## To the installers of ENGLISH LANGUAGE

Fig.2

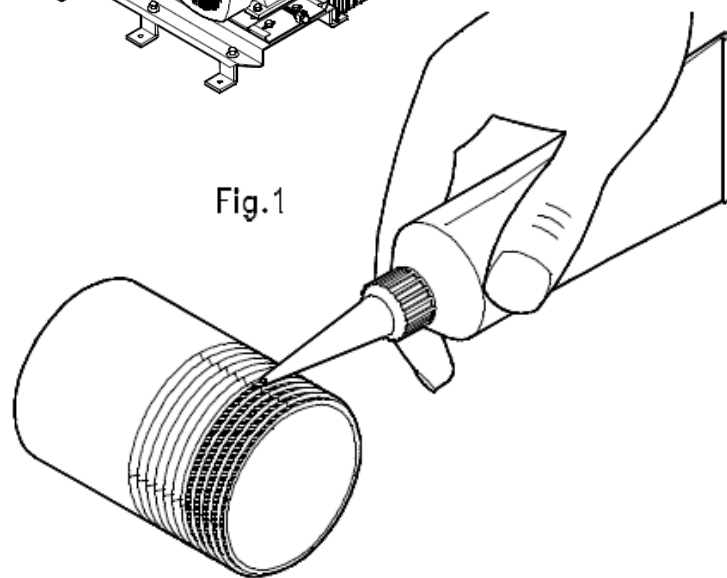
1) To avoid the dispersion of residues of the lubricating oil of the vacuum pump, - image 2 - we ask to the installer of:

- to install a tube B2 joined to the valve of exit V by a union elbow B1,
- to put a drain tank B3 under the tube B2,
- to insert the flexible tubes A1 and A2 in a drain tank A3,
- to make a hole of bleed F on both the tanks.

2) The defective tightness of the threaded junctions of the group separator-silencer is source of drippings of lubricating oil with consequent formation of anaesthetic and ant hygienic sludges.

To avoid losses we ask to the installer to apply a motor silicone gasket - fig. 1:

- on the threaded junctions of the group separator-silencer - image 2, pos. from 1 to 7,
- on the threads of the nipples of recovery oil - image 2, pos. 8 and 9.

**Note:** exclusively to use plastic gaskets based on silicone. We suggest the following makers:

**Loctite 209079 Art.26807, Arexons Art.motorsil D,**

**Wurth Art.0893 260 100 - S, Angst + Pfister**
